Addendum

Solicitation Name	Alterations at Isabella Towers C20014	Addendum Number	3	Date	12/2/19
--------------------------	---------------------------------------	------------------------	---	-------------	---------

ADDENDUM NUMBER 3 - ELECTRICAL

ISABELLA TOWER RENOVATIONS

A0.1

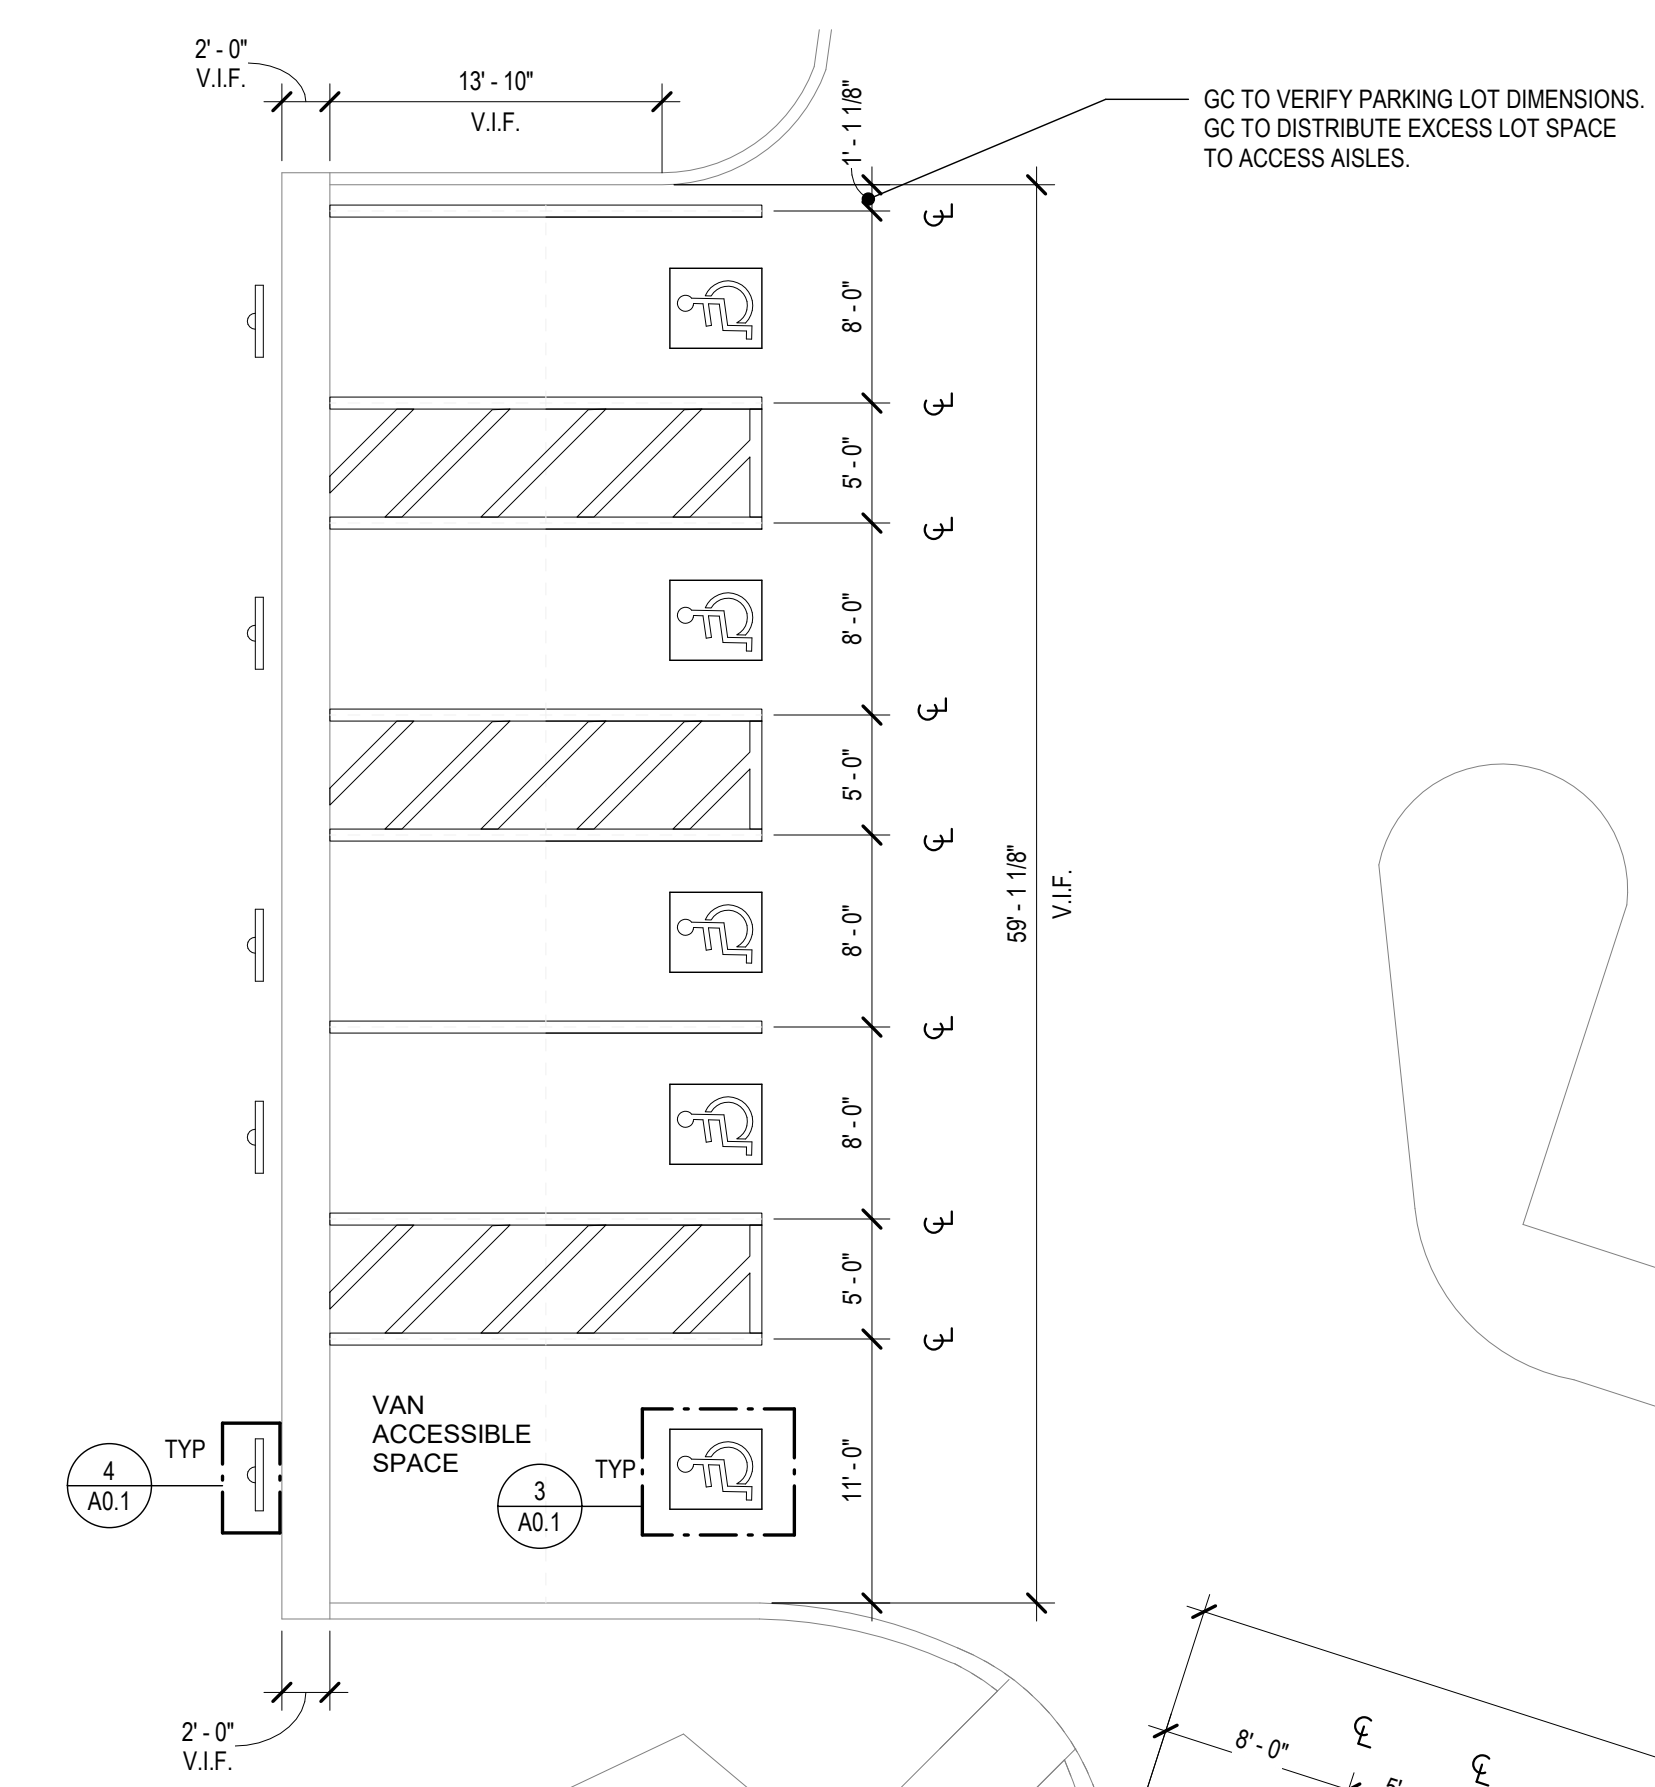
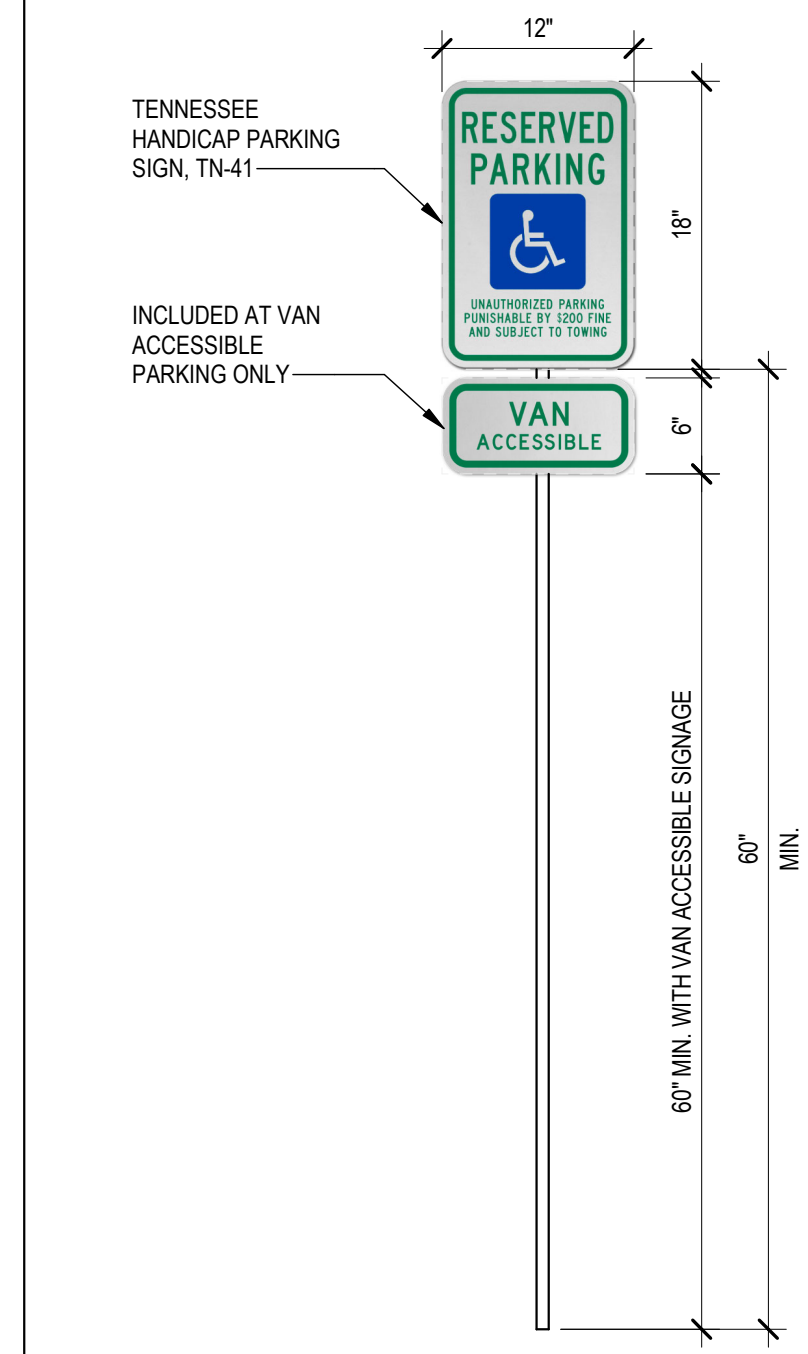
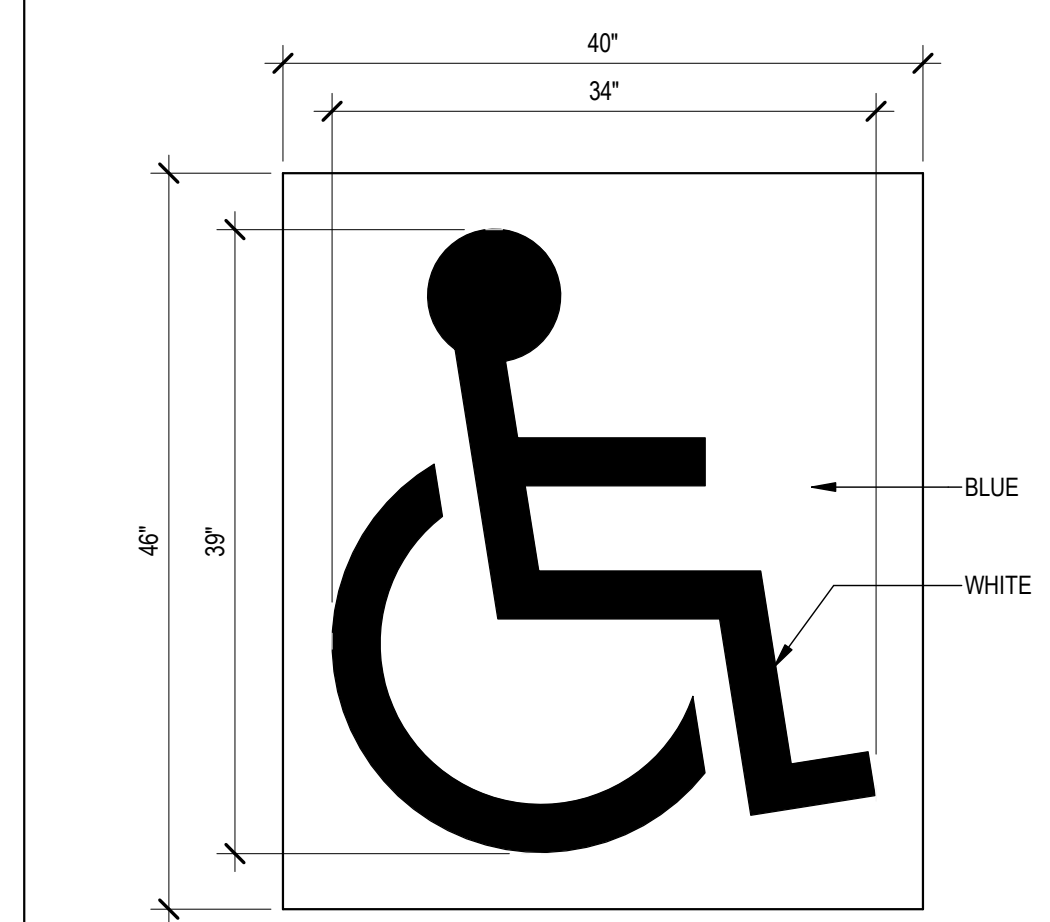
Q1	Page A 0.1, Detail #7 Who will be responsible for the pursuing a determination regarding compliance of the existing ramp as it relates to this detail?
	There will be no site work, except for restriping of the parking lot, to provide accessible parking spaces. Please see attached revised Sheet A0.1.
Q2	As with the Love Tower Project, In regards to the countertop spec for the Isabella Tower project, the material called for is a solid color through material rather than a standard laminate, typical in other KCDC projects. Due to the material costs and additional labor during the production process, there is almost a 1,000% cost increase from a standard laminate top. The manufacturer typically references this material for casework finishing and not as a laminate top. Although not called for on this project, it is also not post-formable. Additionally, due to its properties, it has a large amount of expansion and contraction with temperature change and is considered fragile/brittle, chipping and breaking more easily than standard laminate product. We believe it would be both beneficial to the project schedule and cost, both short and long term, to use a standard Formica or Wilsonart material for these projects. If you need specific data sheets to this effect I can send whatever additional info you may need.

E1.1

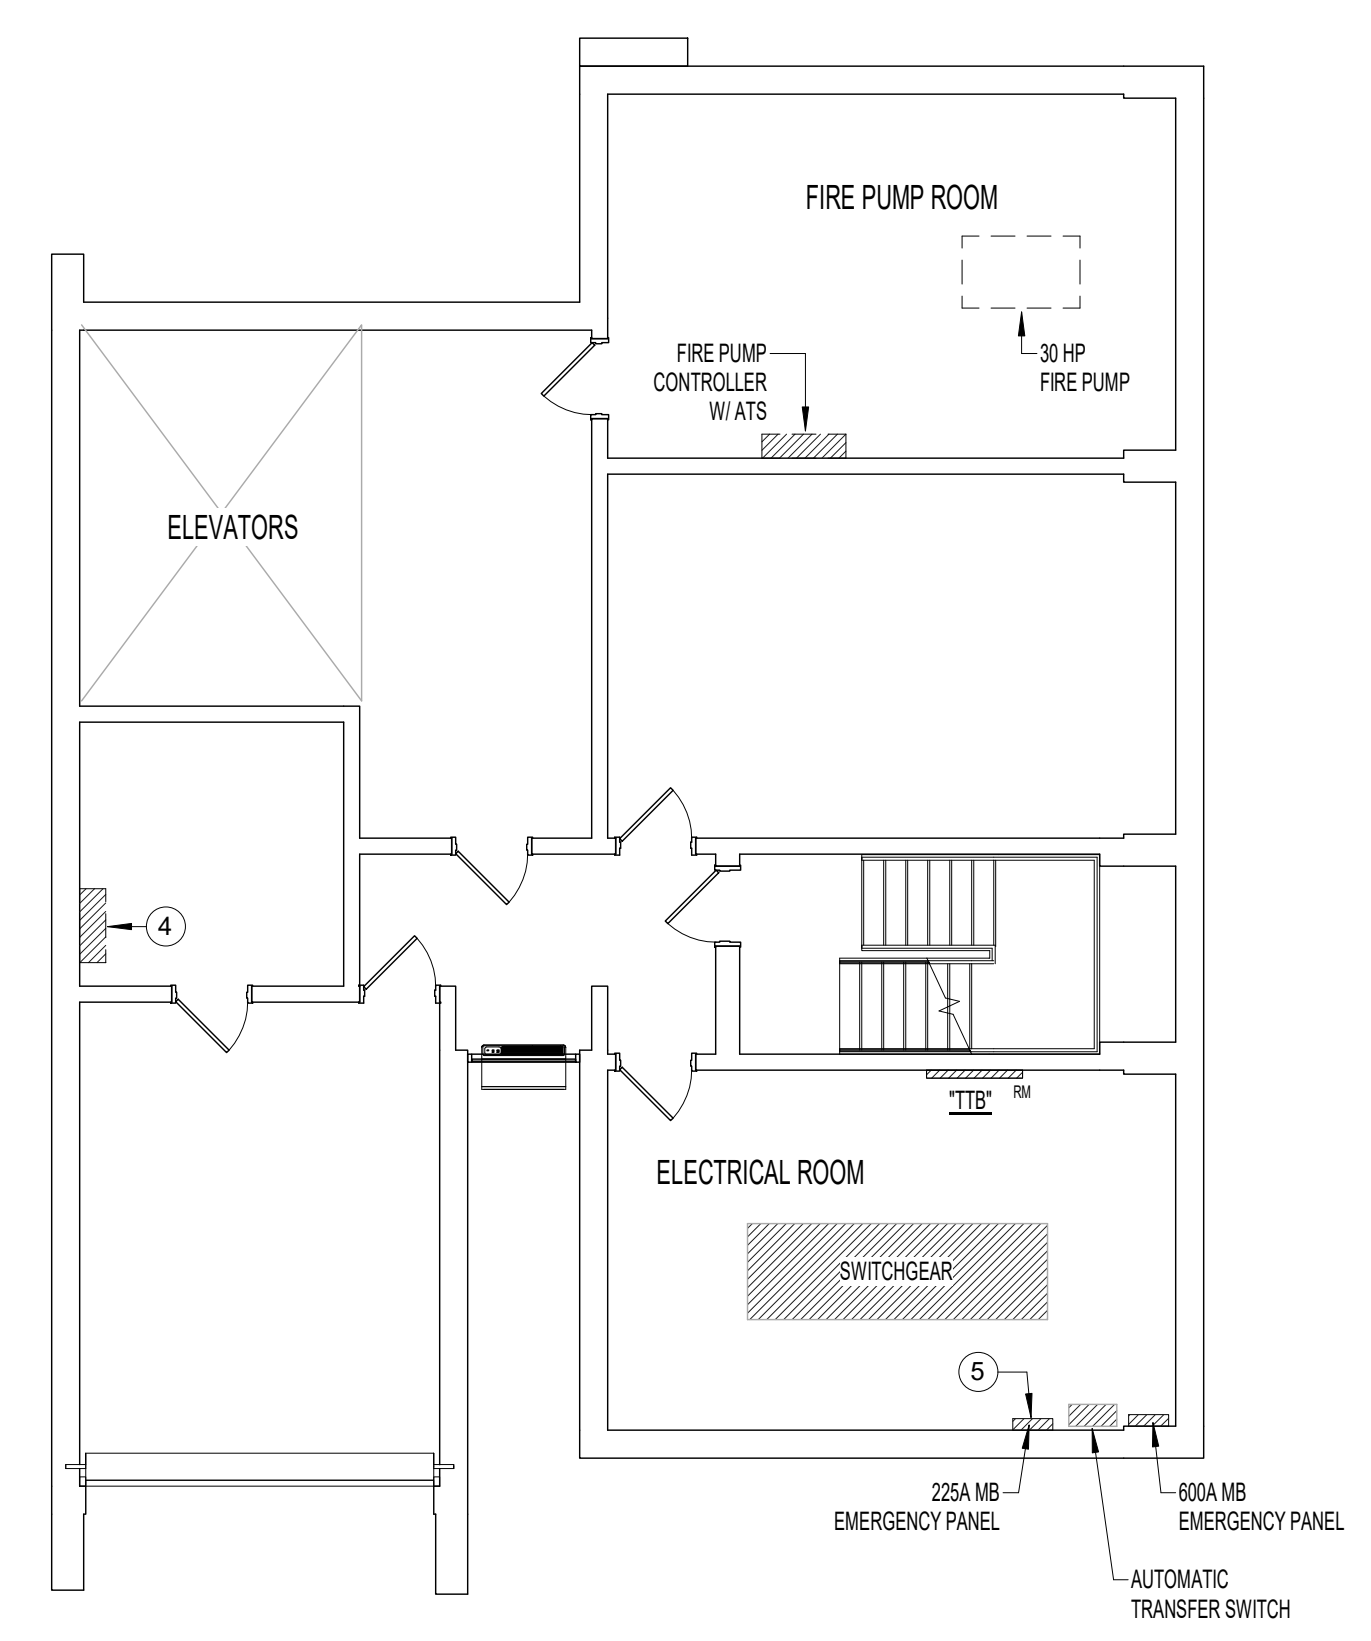
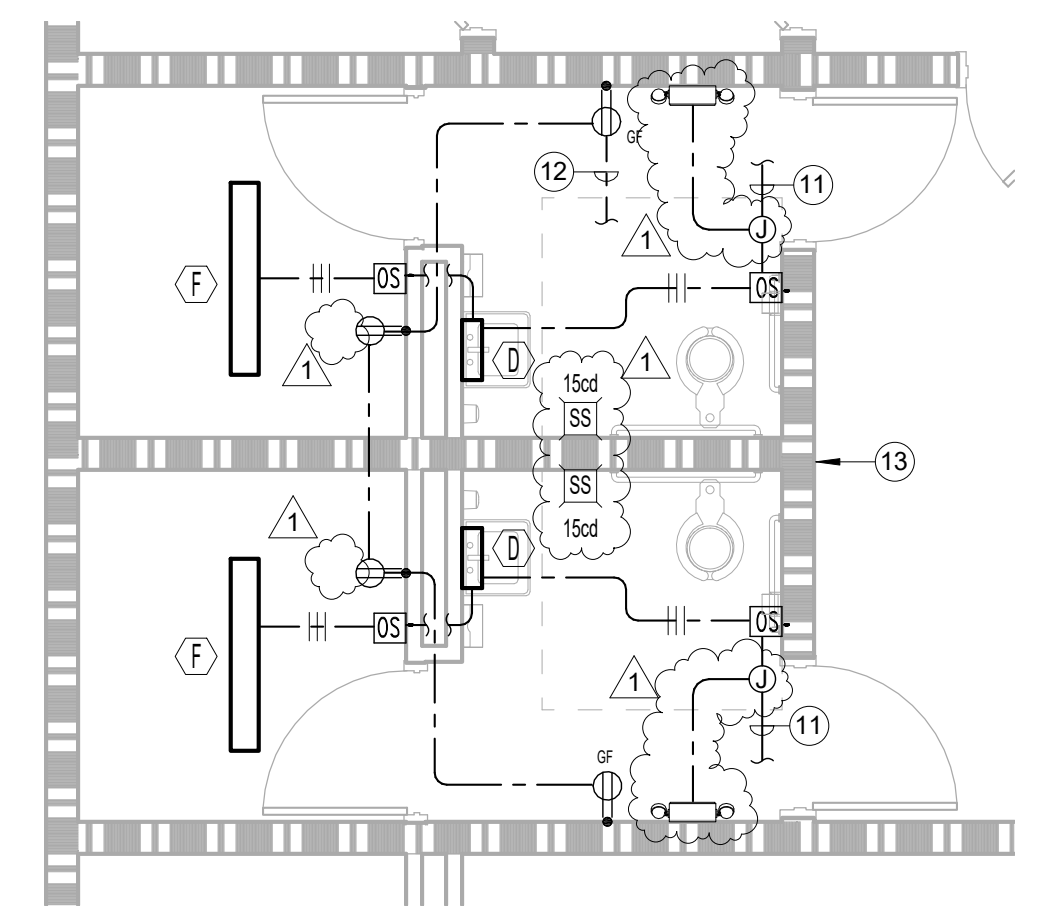
4. Refer to attached revised drawing E1.1 for additional emergency lighting and fire alarm devices in renovated common area bathrooms and correction of some note typos.
